Updated:	May 14, 2021
Project:	Brodie Oaks Redevelopment, Development Assessment
Purpose:	The goal of the Comment log is to list all items discovered in the quality review process that need to be addressed by the project team and whoever is responsible. While QC comments and edits are frequently recorded as redlines directly on a document, some deliverables or agencies require that they be captured in a separate log. Consistent use of a comment log to track and respond to comments during a project’s duration helps facilitate communication and fosters the resolution of questions, comments, and markups.

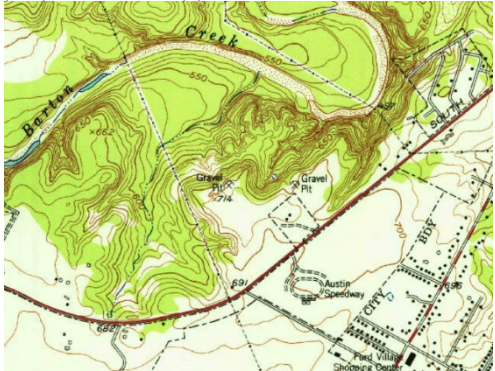
27.	12/27/2020	Development Assessment	12/08/2020	Comprehensive Plan Review-Kathleen Fox	N/A	<p><i>Connectivity</i> This site is adjacent to CapMetro’s Metro Rapid Route 803, along the S. Lamar Boulevard Imagine Austin Corridor. Per the agent: The Brodie Oaks Redevelopment will support ridership on Capital Metro’s existing high-capacity transit route (MetroRapid Route 803) on S. Lamar Boulevard with the development of a high-density, mixed-use project. Shared parking and travel demand management strategies will reduce reliance on single-occupancy vehicles. Existing mobility options in the area are fair while connectivity options are above average.</p>	The Brodie Oaks Redevelopment team met with ATD and Capital Metro on 3/31/2021 and Austin Transportation Department on 3/15/2021 to discuss the coordination of a Purple Line high capacity MetroRapid Route 803 transit stop. A shared parking strategy and a travel demand management plan is included in PUD Submission 1.	Complete

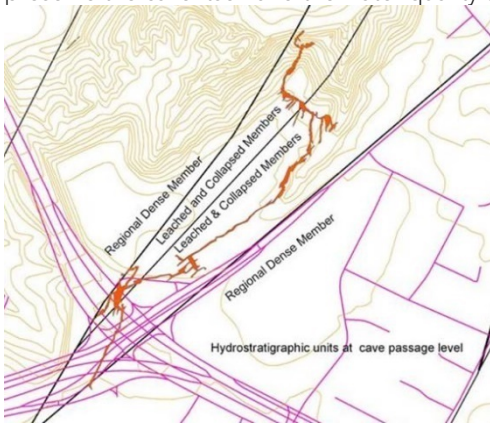
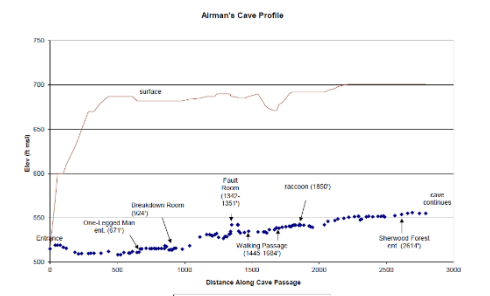
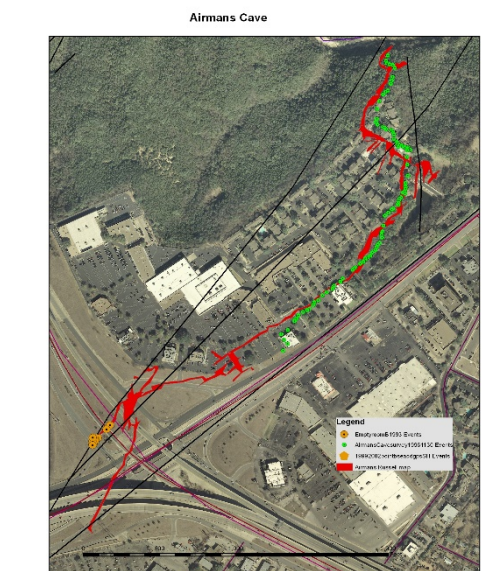
38.	12/27/2020	Development Assessment	12/08/2020	Environmental Officer- Chris Herrington and Atha Phillips	N/A	EO 4. Add private vs. public park location to parkland exhibit for PUD submittal. Provide acreage total for both types of parkland.	Included in PUD Submission 1, Exhibit D- Brodie Oaks Redevelopment Park and Open Space Plan has been modified to reflect this comment. All parkland will be private, but a recreational easement is included to ensure public accessibility is maintained in perpetuity.	Complete

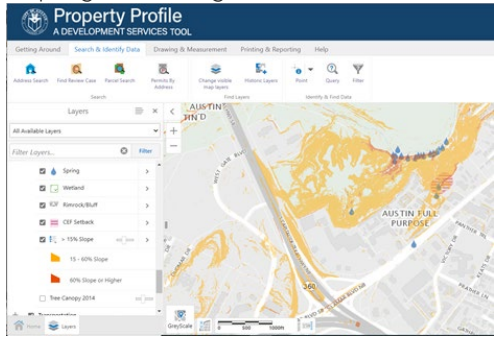
41.	12/27/2020	Development Assessment	12/08/2020	Environmental Review- Jonathan Garner	N/A	EV2 (Tier 2 Requirements) Environment/Drainage – Reirrigation: the proposed plan for reirrigation places the sprinklers in a natural area with highly erosive Del Rio clay soils that will compact and result in large sediment and debris running downgradient to the tributary and main channel of Barton Creek. In addition, the construction required for including this site element will disturb an area of the site that has not been disturbed throughout the life of the existing project. Staff strongly suggests relocating the reirrigation areas and include a more innovative, integrated green storm water control facility in the proposed PUD.	<p>Comment observed and noted.</p> <p>Approximately 10 acres is needed for reirrigation. The project needs to find 10 acres of land to provide reirrigation and meet the SOS Ordinance. If the project foregoes current entitlements to re-irrigate in the parkland, the Brodie Oaks Redevelopment will need to re-irrigate in the proposed parkland on-site. The provided Park Development Plan addresses the need to co-locate reirrigation and park amenities by:</p> <ul style="list-style-type: none"> Minimizing reirrigation in select high traffic and highly programmed areas. Constructing the reirrigation system to allow certain areas to be turned off or re-scheduled if necessary. Designing parks and amenities that can be co-located with reirrigation, including education and information about the SOS Ordinance and how stormwater is being treated on the site. 	Complete
